DATE: April 30, 1970
TO: Owners and Operators of Yankee Aircraft
SUBJECT: Canopy Improvements
MODELS AFFECTED: All Model AA-1
TIME OF COMPLIANCE: Any time at owner's discretion

Item 1 - Canopy Tracks

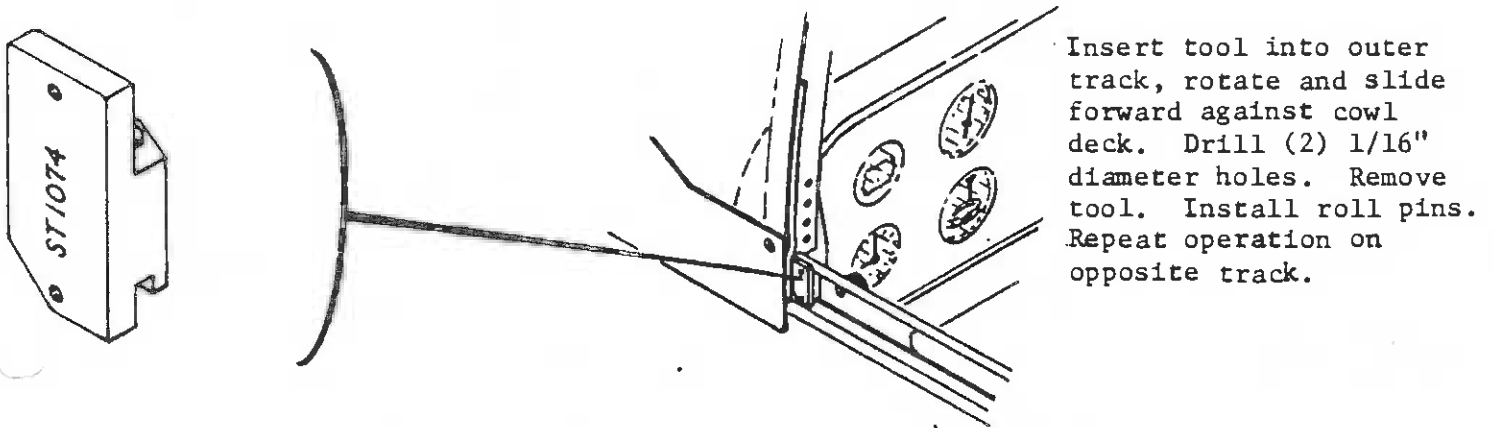
6. Aircraft delivered from the factory after April 21, 1970 have the teflon glide material secured in the outer tracks with a roll pin, Essna Part No. 52-012-062-0500, inserted at the forward end of each channel. Aircraft delivered prior to April 21, 1970 can be modified in the field to incorporate this improvement. A Canopy Track Drill Jig, Part No. ST-1074, is available which may be used to assist in locating and drilling holes for field installation of the roll pins. Use of Tool No. ST-1074 is illustrated below.

Item 2 - Canopy Stops

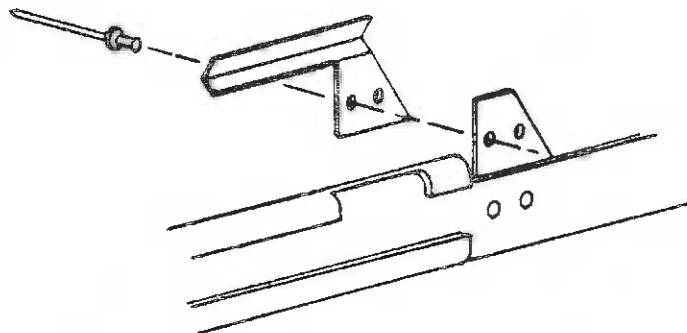
Production aircraft AAL-0190 and up have extended canopy stops installed to limit the rearward travel of the canopy which results in greater support of the canopy track in the forward canopy bow attach area. Extended stops, Part No. 102371-1 and 102371-2, which are secured in place with Part No. 1601-0410 pop rivets, can be installed on aircraft prior to AAL-0190 as illustrated below.

Line up extended stop over existing stop. Drill (2) .136/.139 diameter holes and rivet stop in place. Repeat on opposite track.

Item 3 - Canopy - Windshield Seals

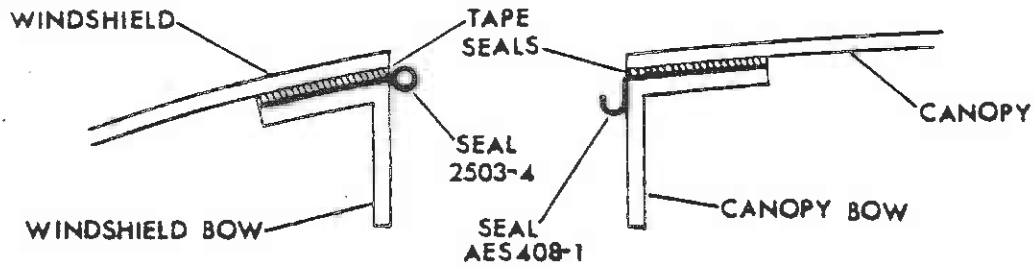
Improved seals at the canopy-windshield junction have been installed on Aircraft AAl-0262 and up and are being supplied for all spares requirements for earlier aircraft. The new windshield seal, Part No. 2503-4, and canopy seal, Part No. AES408-1, are positioned between the plexiglas tape seal and the windshield-canopy bow as illustrated below.
